**Honorable Chairman and Members of the  
Hermosa Beach Planning Commission**

**Regular Meeting of  
February 17, 2004**

**SUBJECT: APPEAL OF DIRECTOR'S DECISION – STAIRWAY ENCROACHMENT FOR  
PROPOSED ROOFTOP DECK AT 516 BAYVIEW DRIVE**

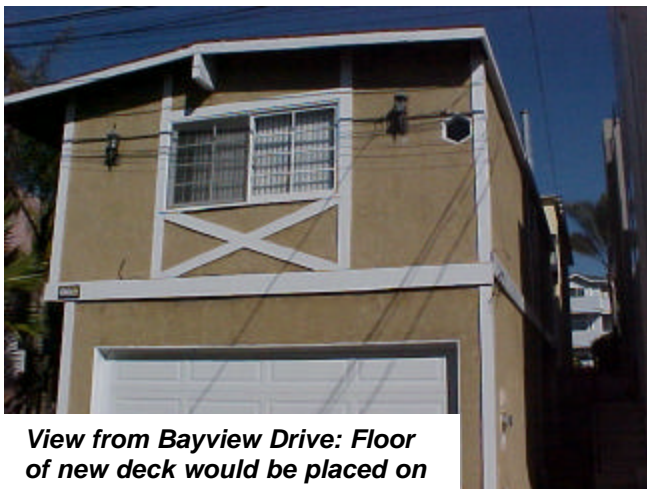
*View from Bayview Drive: Floor of new deck would be placed on top of the existing roof ridge and approximately 12 feet back from the front eaves.*

*Side view from Bayview Drive: The existing second floor deck is visible through the railing.*

*Side view from Monterey Boulevard: The existing second floor deck can be seen behind wall of house in front.*
